**SUBJECT: VERMONT YANKEE NUCLEAR POWER STATION - ISSUANCE OF
AMENDMENT RE: REVISED REACTOR VESSEL PRESSURE-
TEMPERATURE LIMITATION CURVES (TAC NO. ME5252)**

Amendment No. 250
License No. DPR-28

SAFETY EVALUATION BY THE OFFICE OF NUCLEAR REACTOR REGULATION

Figure 3.6.1

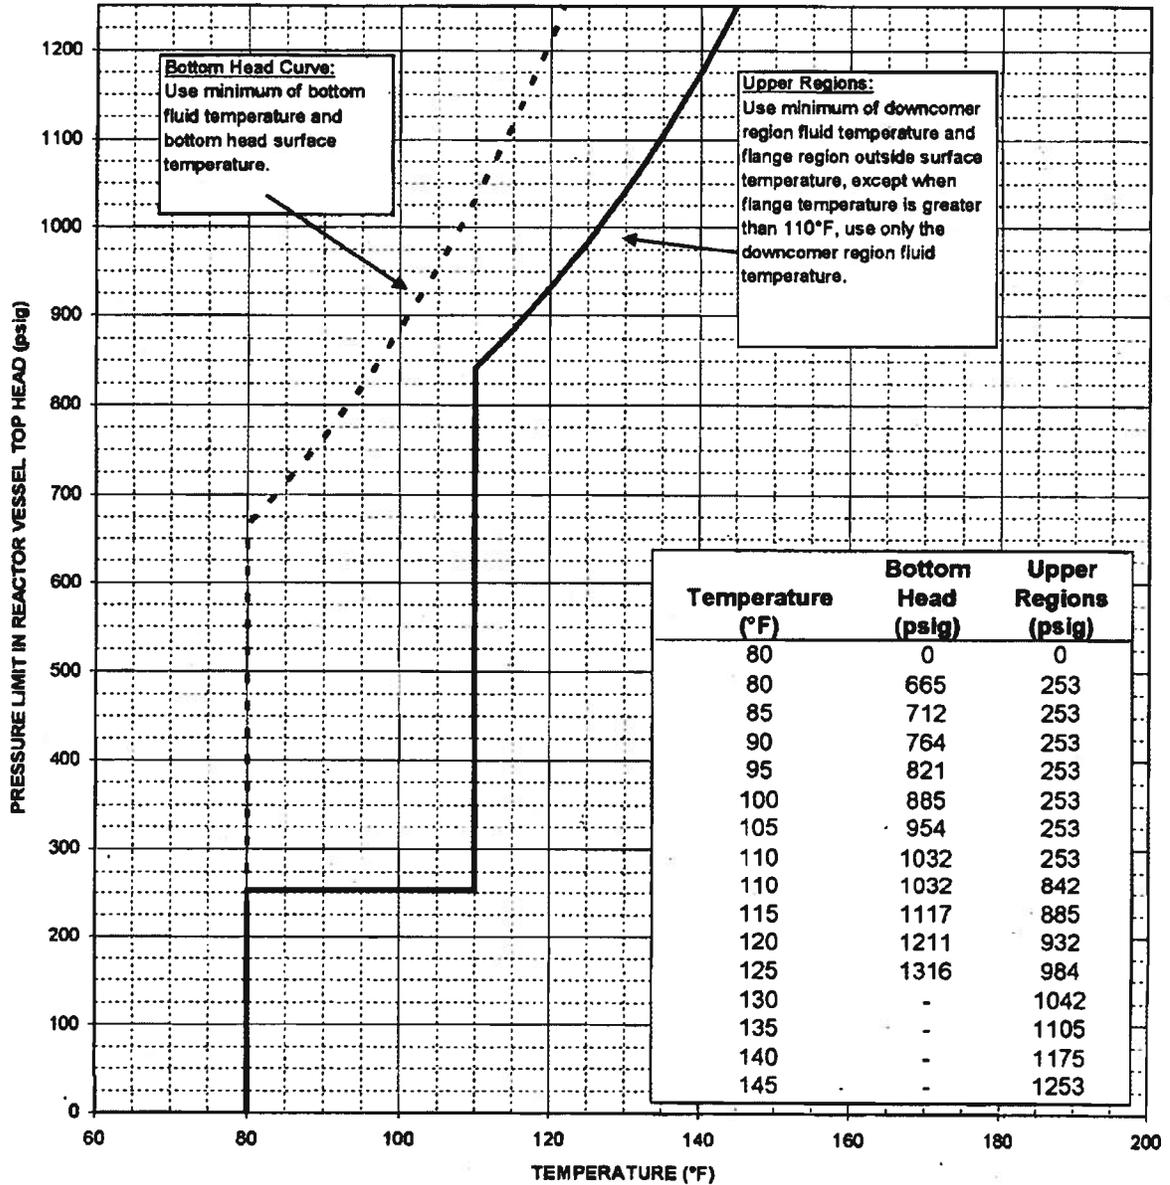
**40°F/hr Heatup/Cooldown Limit
Valid Through 7.943'E8 MWH(t)**

The licensee proposes updating the bounding run-time to 7.943×10^8 MWH(t), corresponding to a bounding 1/4T neutron fluence of 1.24×10^{18} n/cm², while the licensee predicts that the RPV will only reach a 1/4T neutron fluence of 5.39×10^{17} n/cm² by the end of a 20-year license renewal (LR) period (for a total of 60 years of licensed operation). This update would support operations into the LR period beyond the original 40-year operating license.

Figure 3.6.3

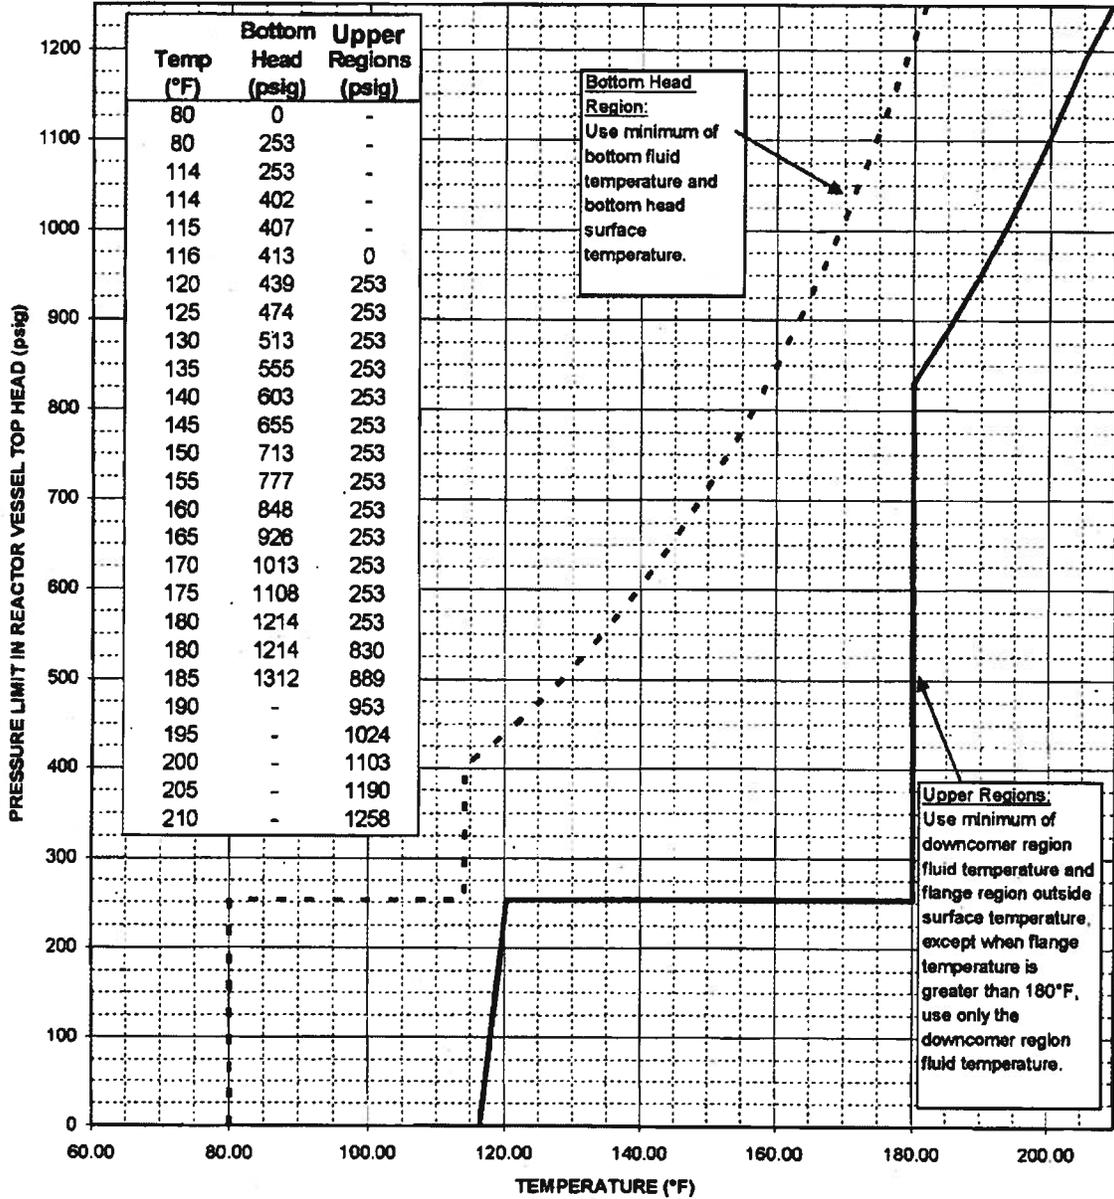
**100°F/hr Heatup/Cooldown Limit
If Pressure < 253 psig, Water Level must be within
Normal Range for Power Operation
Valid Through 7.943 E8 MWH(t)**
